UNITED STATES PATENT AND TRADEMARK OFFICE

APPLICATION NO.	FILING DATE	FIRST NAMED INVENTOR	ATTORNEY DOCKET NO.	CONFIRMATION NO.
10/719,147	11/21/2003	Longin B. Greszczuk	BING-1-1042	2111
46020	7590	07/13/2005	EXAMINER	
BLACK LOWE & GRAHAM PLLC 701 FIFTH AVENUE, SUITE 4800 SEATTLE, WA 98104			ELLINGTON, ALANDRA	
			ART UNIT	PAPER NUMBER
			2855	
DATE MAILED: 07/13/2005

Non-Final Rejection

FIG. 1

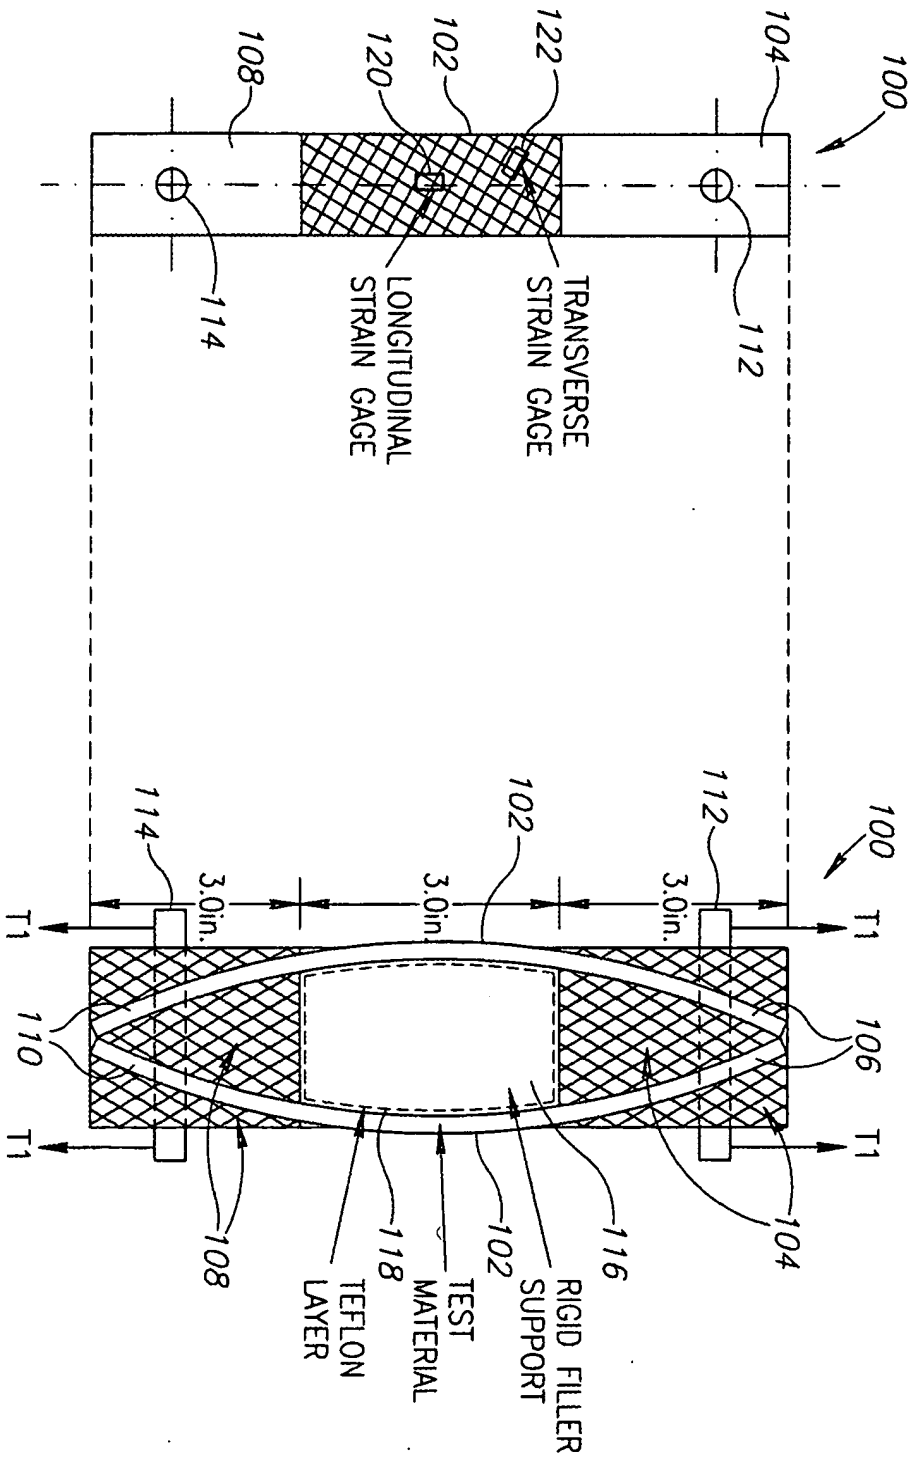
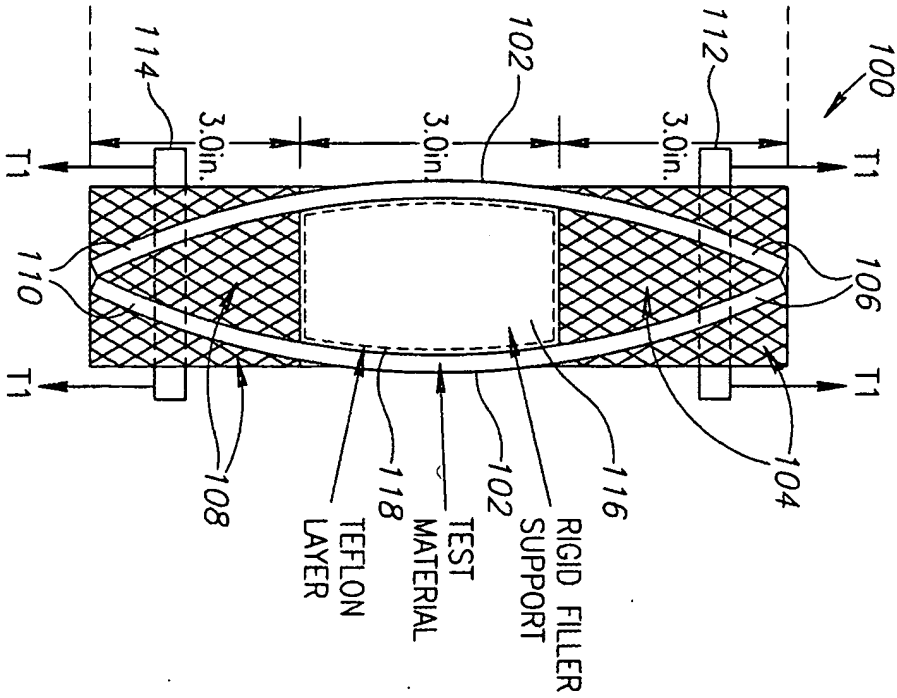
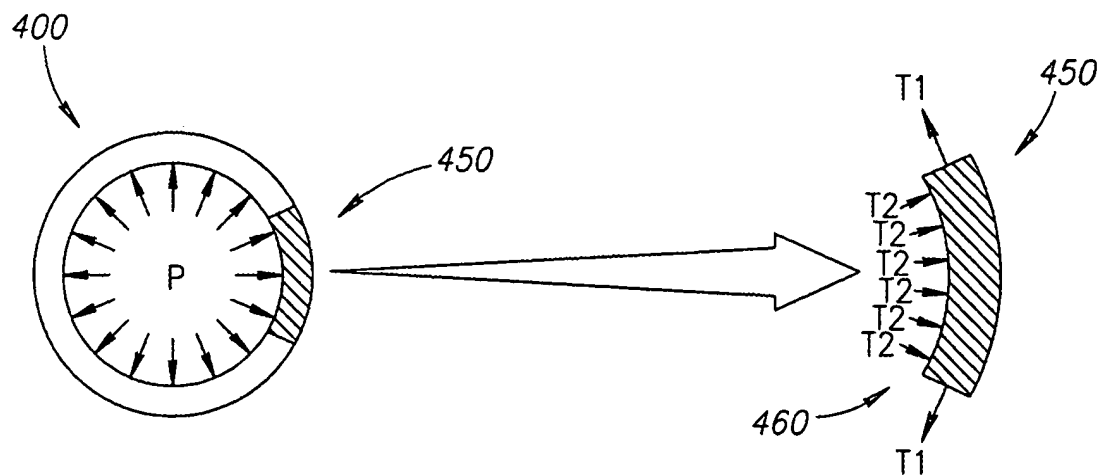
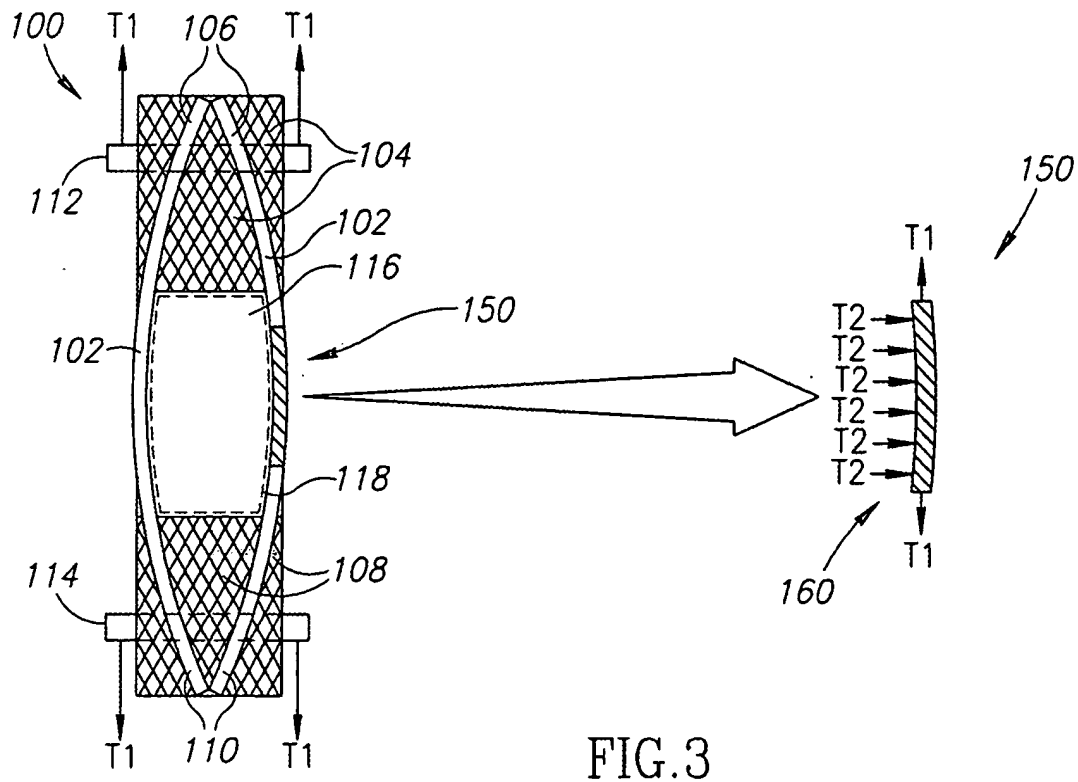
1. The drawings are objected to under 37 CFR 1.83(a) because they fail to show a *rigid member having a pair of curved outer surfaces adapted to be engaged against at least a portion of each of the first and second curved specimens* (claim 1) as described in the specification. Any structural detail that is essential for a proper understanding of the disclosed invention should be shown in the drawing. MPEP § 608.02(d). Corrected drawing sheets in compliance with 37 CFR 1.121(d) are required in reply to the Office action to avoid abandonment of the application. Any amended replacement drawing sheet should include all of the figures appearing on the immediate prior version of the sheet, even if only one figure is being amended. The figure or figure number of an amended drawing should not be labeled as "amended." If a drawing figure is to be canceled, the appropriate figure must be removed from the replacement sheet, and where necessary, the remaining figures must be renumbered and appropriate changes made to the brief description of the several views of the drawings for consistency. Additional replacement sheets may be necessary to show the renumbering of the remaining figures. Each drawing sheet submitted after the filing date of an application must be labeled in the top margin as either "Replacement Sheet" or "New Sheet" pursuant to 37 CFR 1.121(d). If the changes are not accepted by the examiner, the applicant will be notified and informed of any required corrective action in the next Office action. The objection to the drawings will not be held in abeyance.
